SYSTEM/MODEL: LEF

MODIFICATION: Convert privacy switch to full time privacy mode

MODIFICATION INSTRUCTIONS

CONVERT PRIVACY SWITCH TO FULL TIME PRIVACY MODE

LEF Schematic of Talk/Privacy Circuit

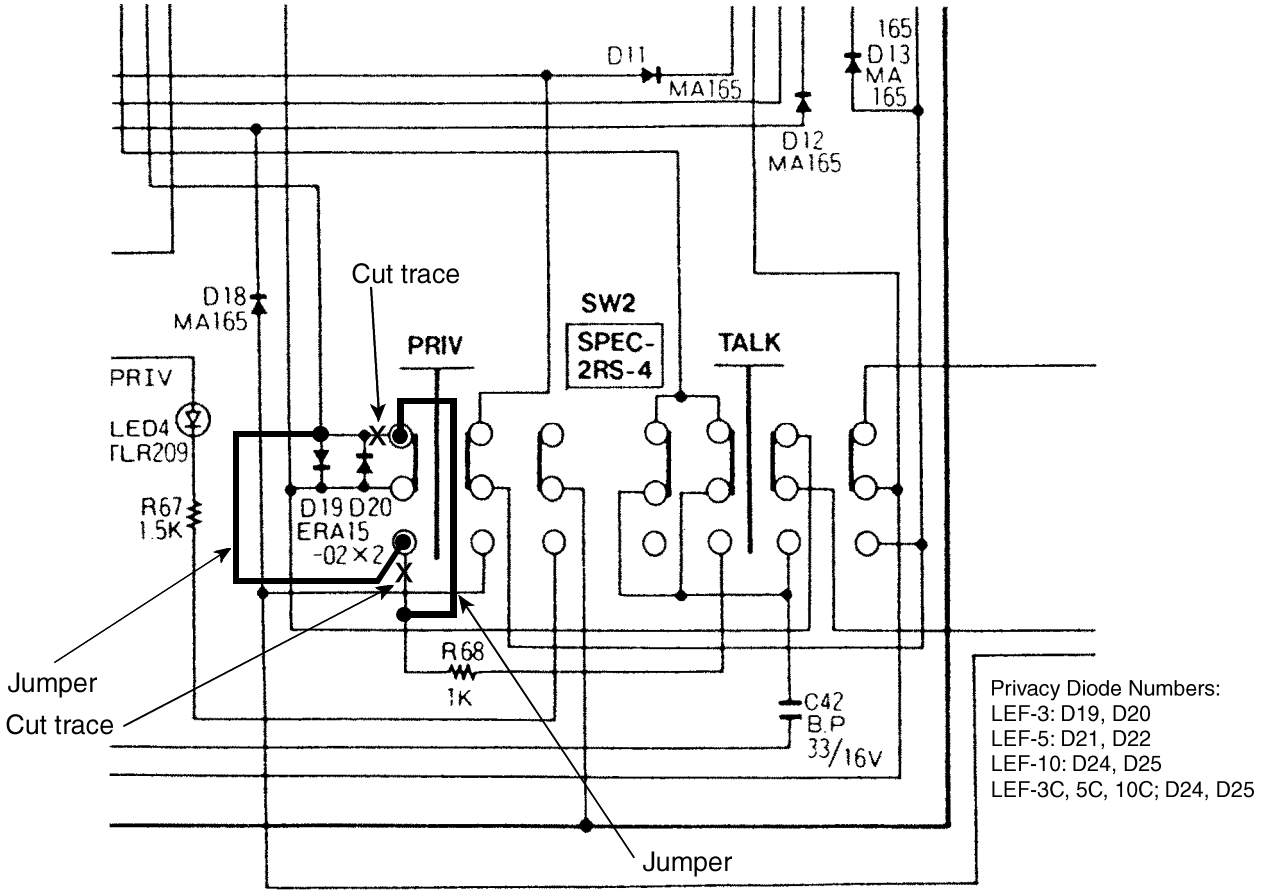
Solder two jumpers in place as shown above.
Cut traces where marked with an "X".

INSERT SMALL SCREW (1mm) in the hole between the TALK and the PRIV switch to make the privacy button momentary instead of locking. (Sub-plate inside switch must be held to the right.)

This modification will put the master station in the privacy mode all of the time. To respond to a call from another master, press the *PRIVACY* switch to talk, and release to listen.
